TECHNICAL NOTE N. 00311/LB – 10/09/2020

Object: ERROR 21 – CONDENSER DRYERS NOT HEATING - PRODUCED FROM DECEMBER 2019 TO MAY 2020

FAULT CODE: 1KLFA

Fig.1

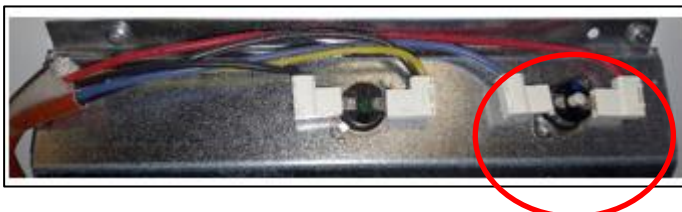
Error E21 is related to the malfunction of the manual resettable thermal fuse on the drying heater, See (Fig 1 and 2 below), a wiring fault, poor ventilation, or the failure of the heater relay on the module.

We have found that **ONLY IN APPLIANCES PRODUCED FROM DECEMBER 2019 (serial date 1948) TO MAY 2020 (serial date 2022)** the most frequent cause of the issue mentioned is due to an intervention setting of the thermostat that is too low at 150 ° C.

To solve the problem Gias provides now manages has defined new replacement heater assemblies specific to each market. The new heaters are fitted with a new thermal fuse set to operate at 200°C:

40015910→ for UK market (all market with supply voltage 240V)

40015909→for all other markets (supply voltage 230V)

Therefore, please replace the original heater with the new code.
